Wollongong Local Planning Panel Assessment Report | 13 June 2023

WLPP No.	Item No. 1
DA No.	DA-2022/1023
Proposal	Residential - demolition works, tree removal, construction of 12 units and 20 townhouses with associated basement car parking, landscaping and services infrastructure
Property	15 Nicholson Road, Woonona; Lot 101 DP 1279511
Applicant	Martin Morris & Jones Pty Ltd
Responsible Team	Development Assessment and Certification - City Wide Team (VL)
Lodgement date	26 September 2022
Prior WLPP meeting	N/A

ASSESSMENT REPORT AND RECOMMENDATION

Title
Area Calculations
Drawing No.
0616-DA136
Revision
01
Scale
1:500 at A1 size
Date
29/08/22

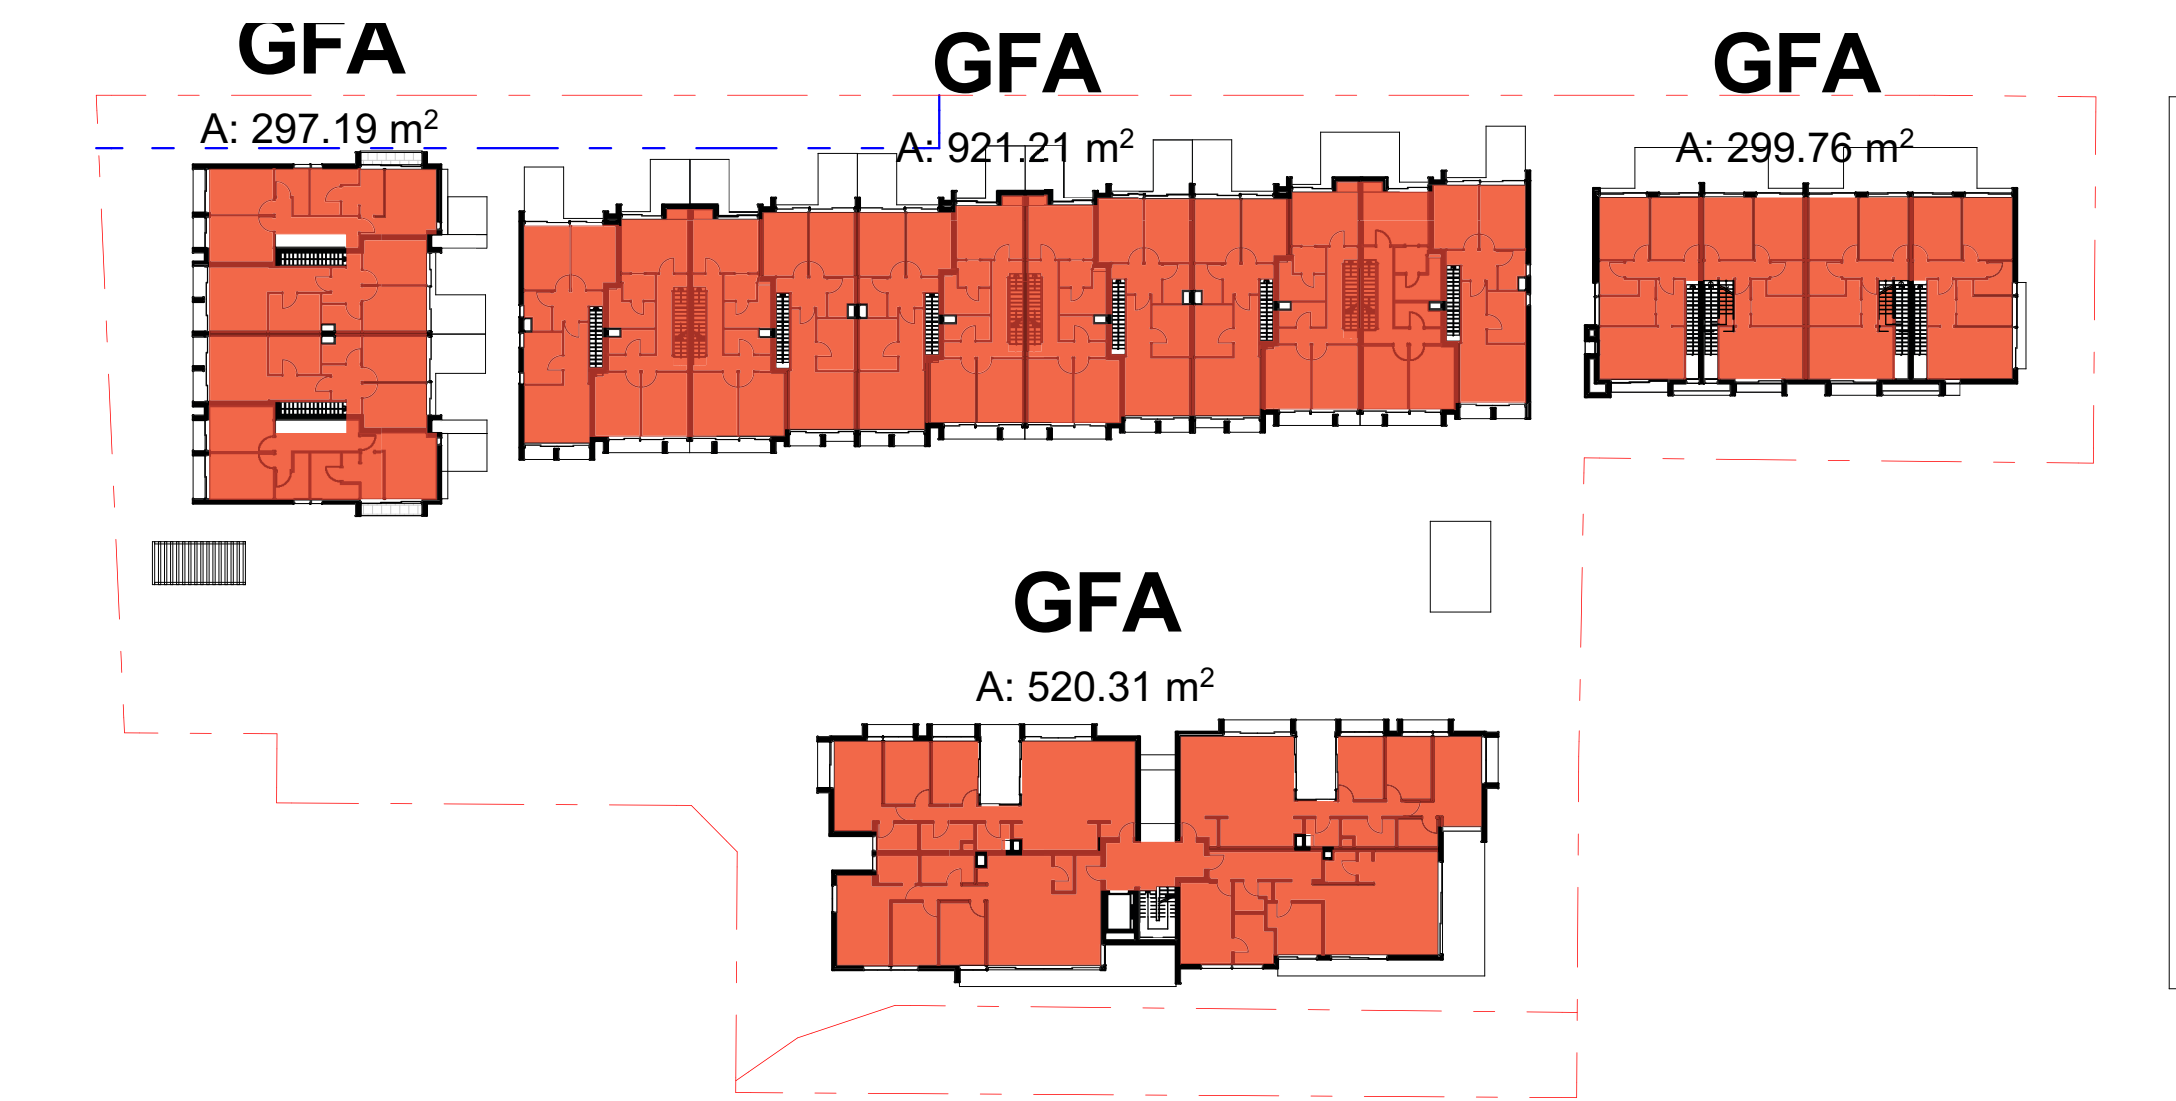
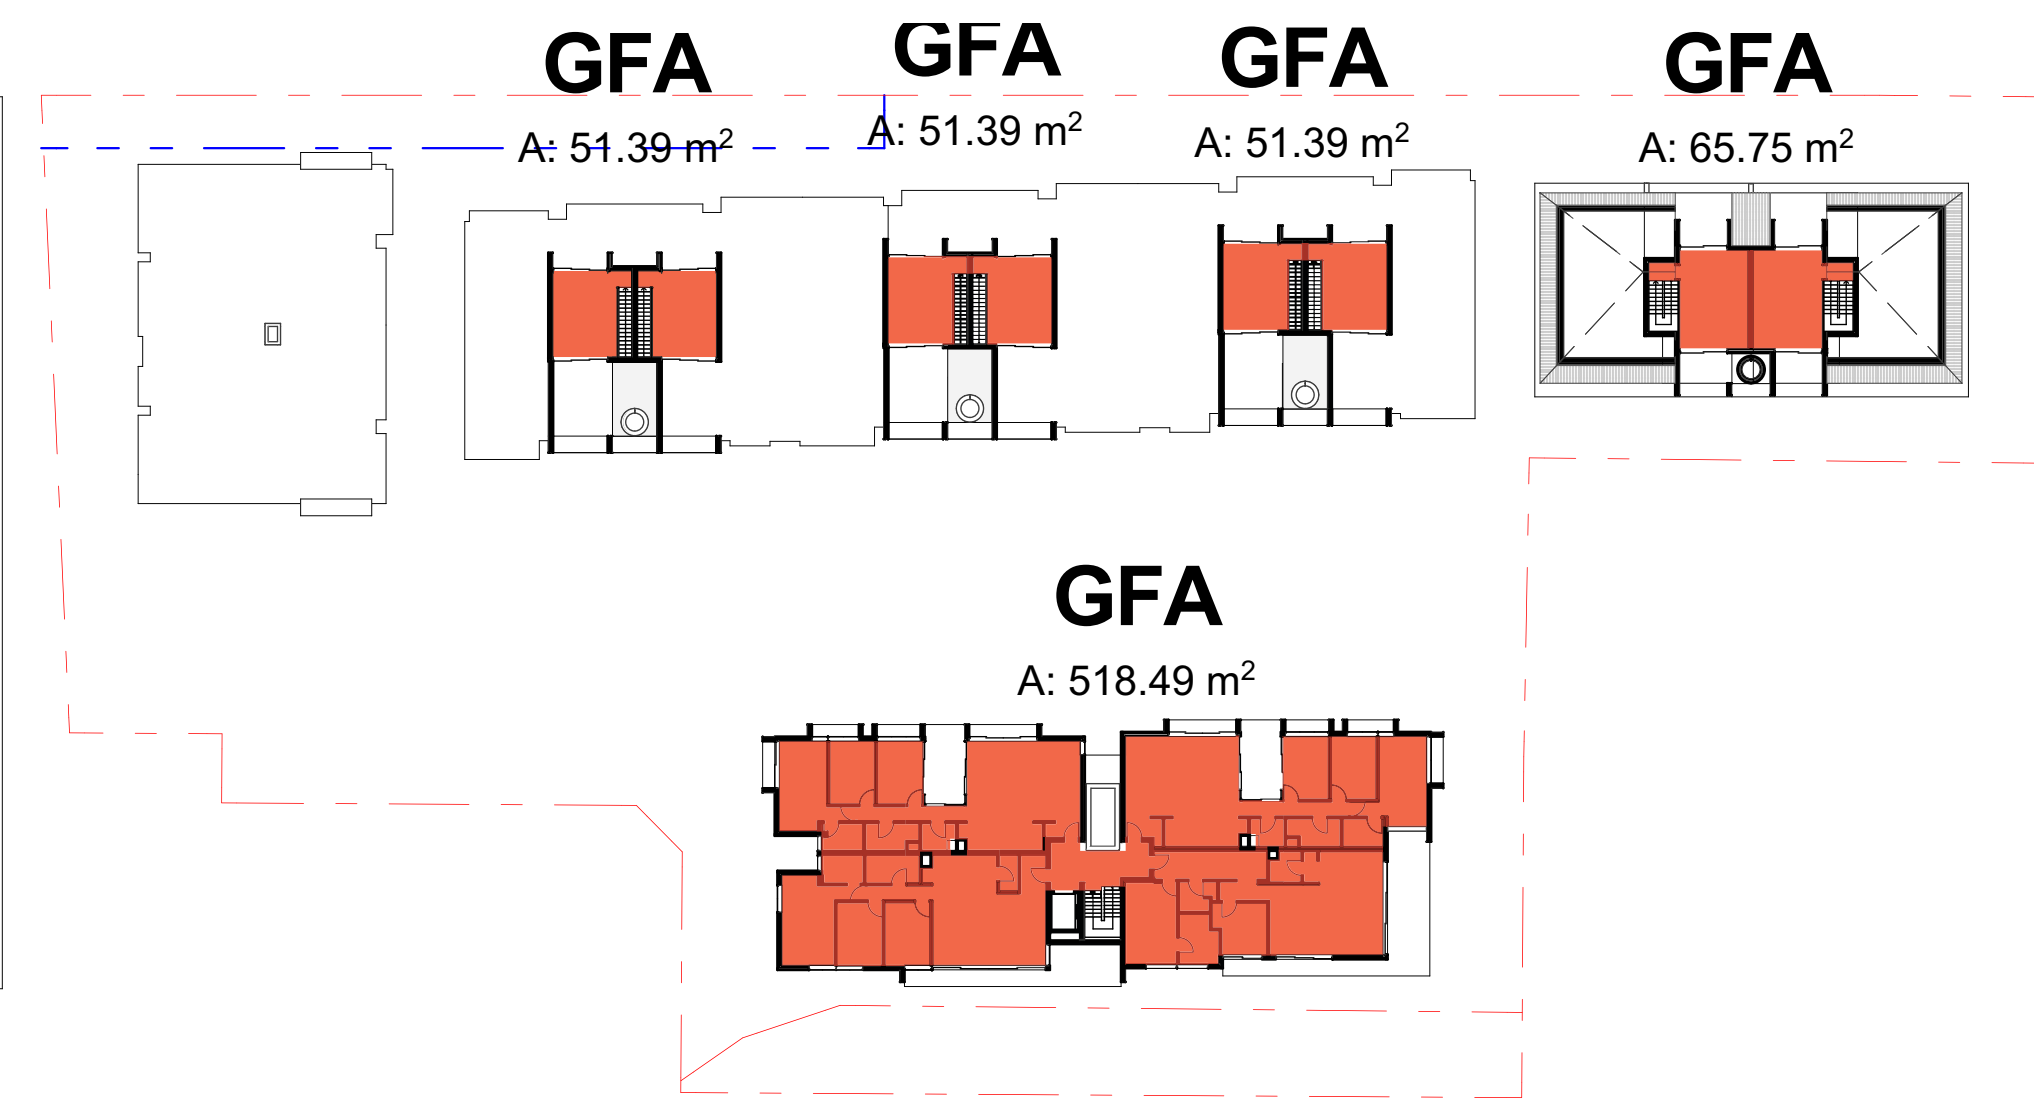
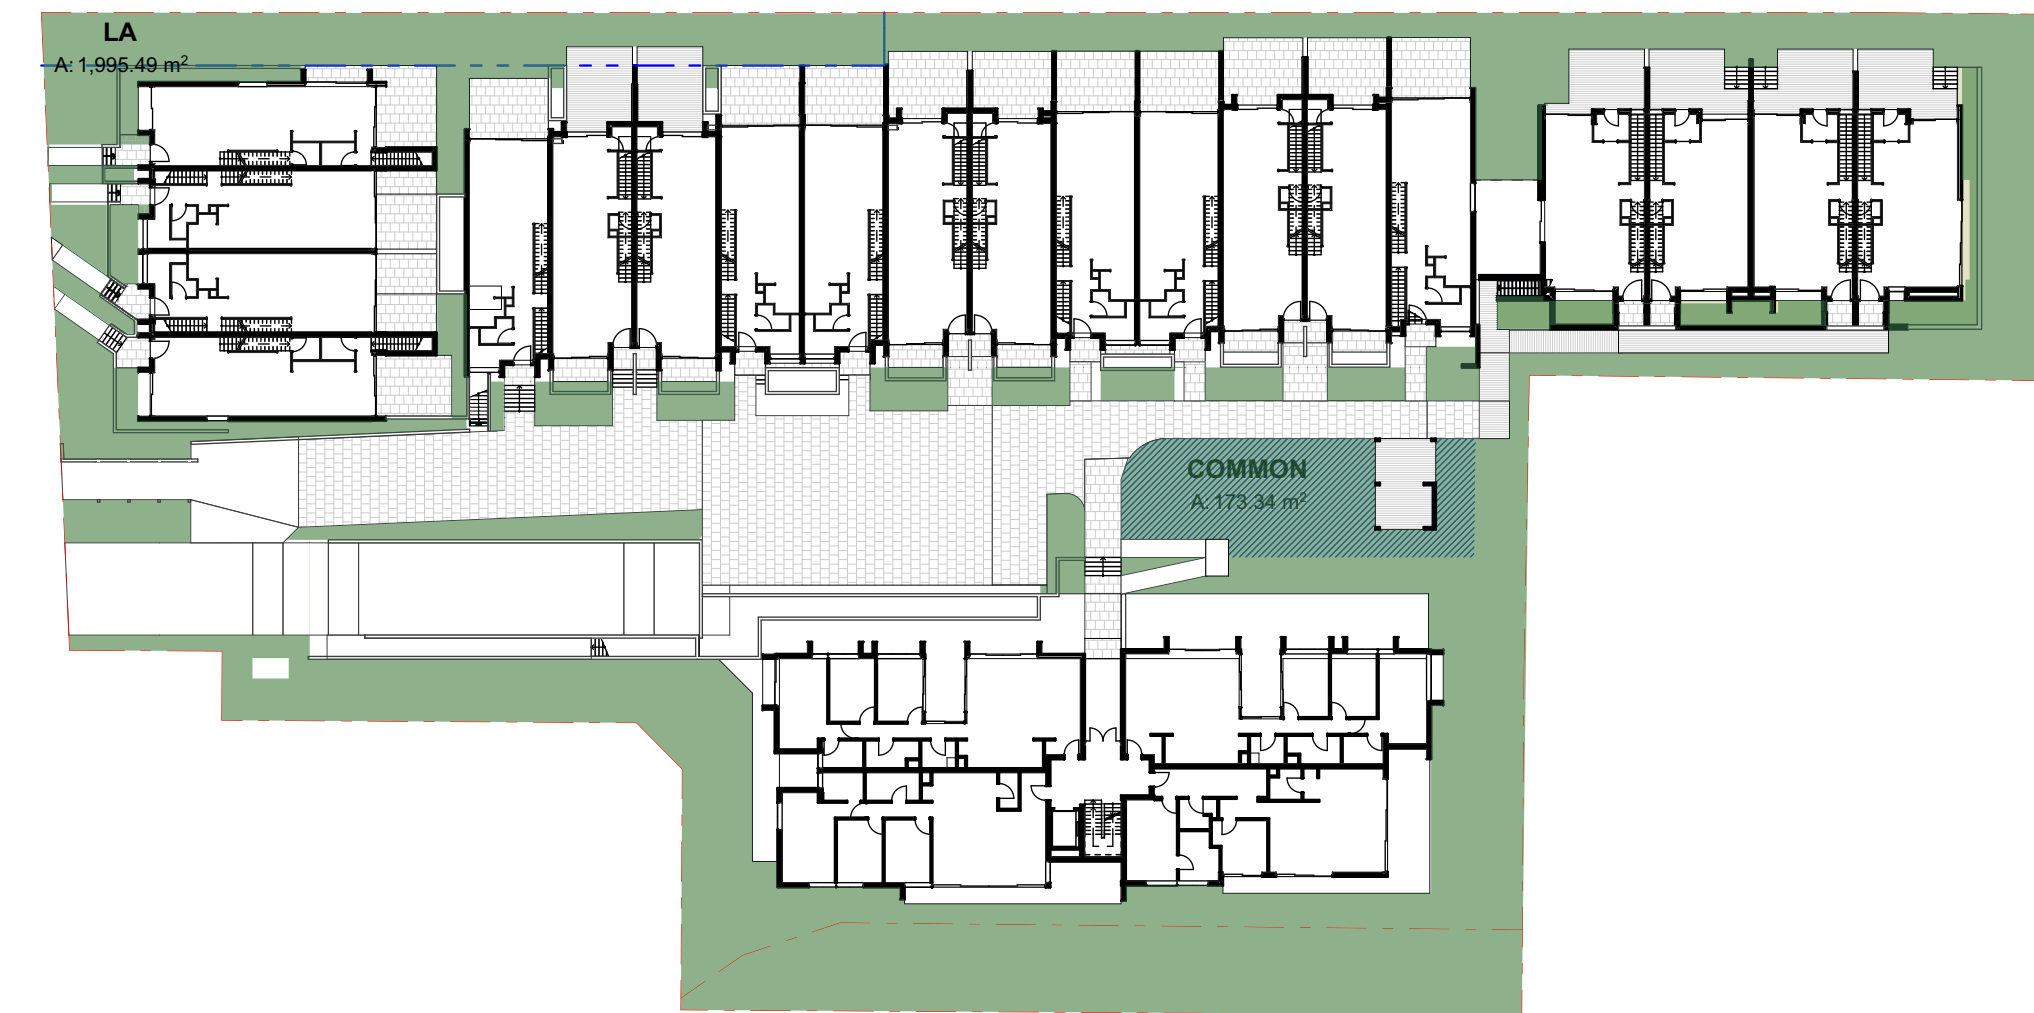
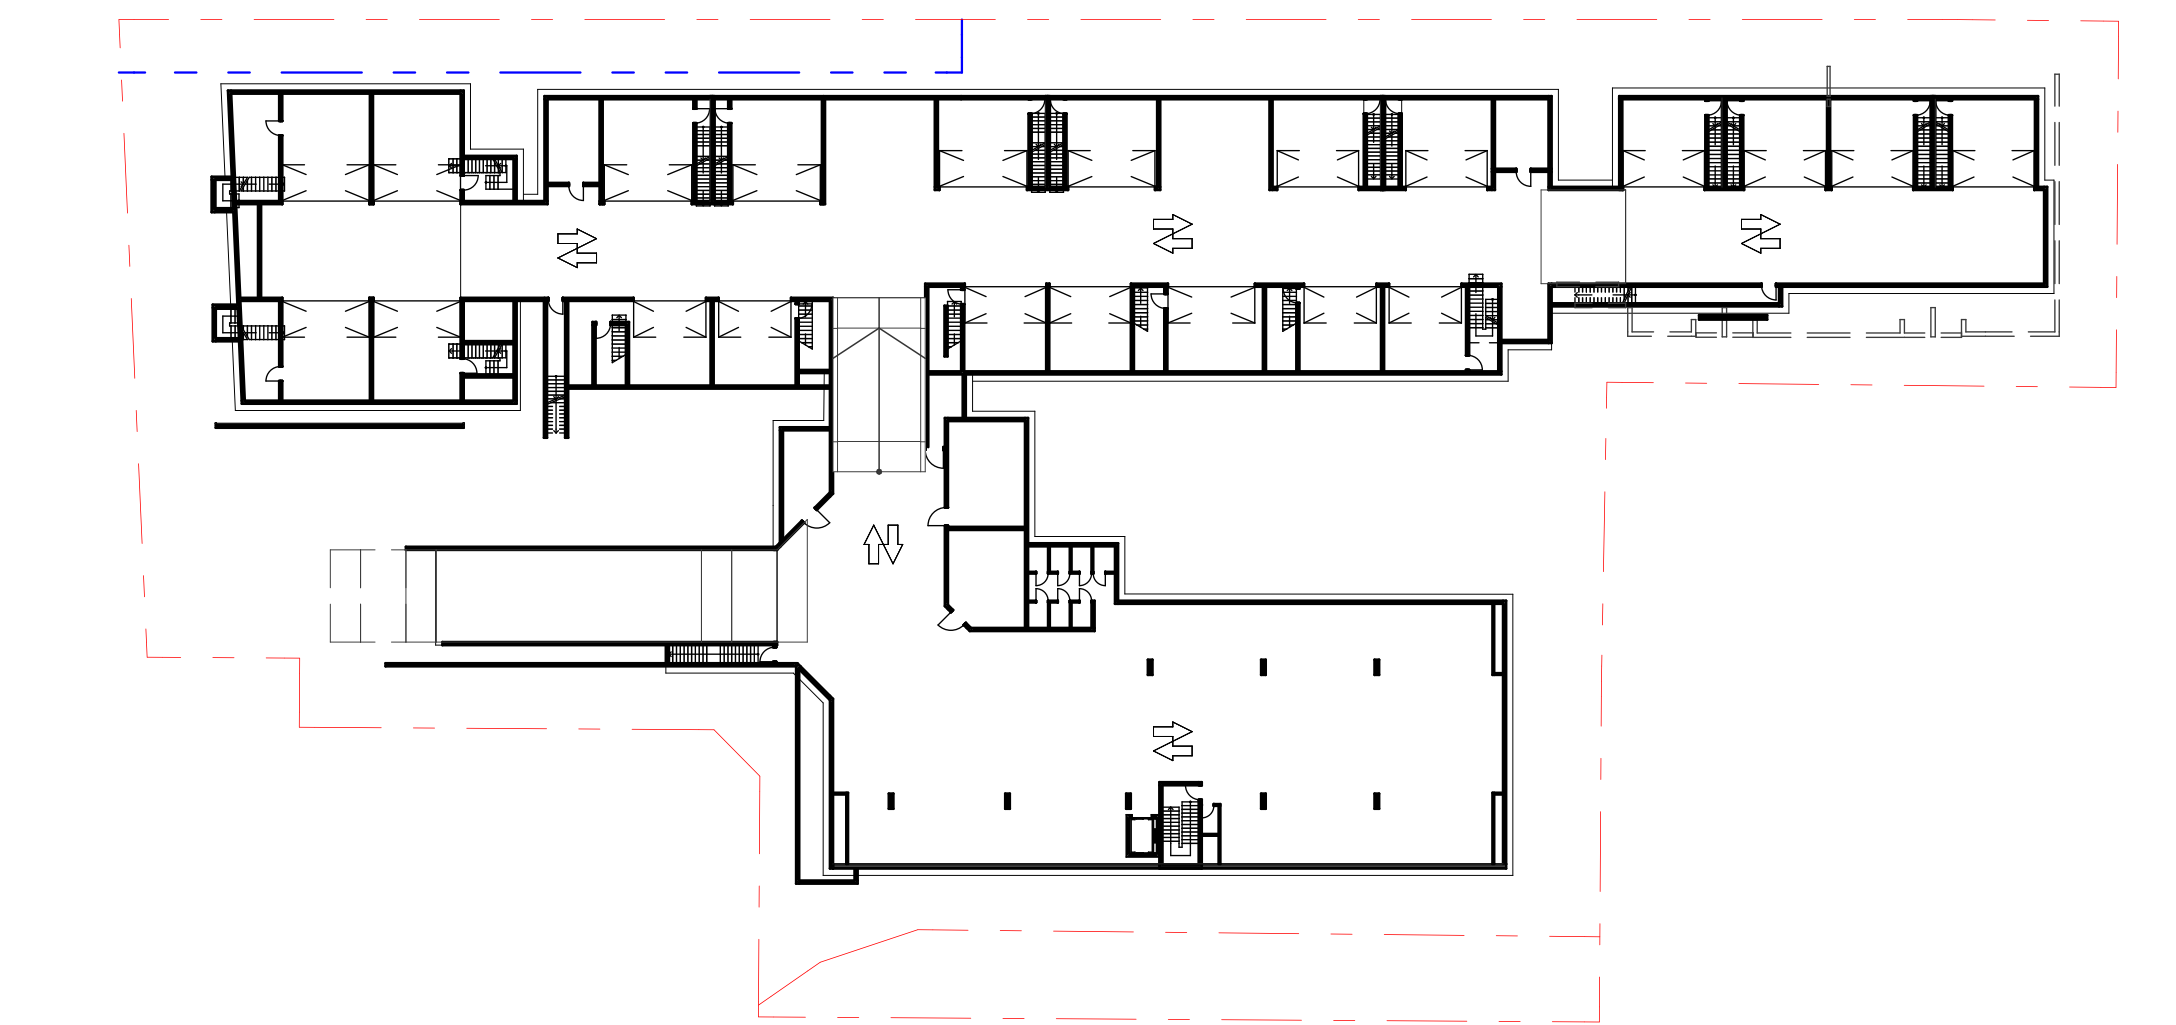
The proposed gross floor area indicated on the submitted gross floor area plans excludes certain areas within the buildings which are included in the definition of gross floor area (GFA) provided by the Dictionary in WLEP 2009.

There appears to be multiple sections throughout the development of lower level areas which have been excluded from GFA on the basis that they are basement but which floor levels immediately above that are more than 1m above existing ground level. Limited cross sections have been provided to detail the relationship between the proposed development and existing ground levels, noting significant excavation is proposed to accommodate the built form. However, it has been identified along the north, south and eastern façade of the residential flat building and the eastern elevation of Building C that the floor above the “basement” will exceed 1m above existing ground level. Situated in these areas are storage areas for the units and vehicle access. As they do not meet the definition of a ‘basement’ in WLEP 2009, these areas should be included in the GFA calculations.

As discussed in section 2.25 above under Clause 4.4 of WLEP 2009, the applicant identifies the FSR as compliant however, it is considered based on the plans submitted the FSR for the proposal will exceed the maximum of 0.75:1. No written request pursuant to Clause 4.6 has been provided.
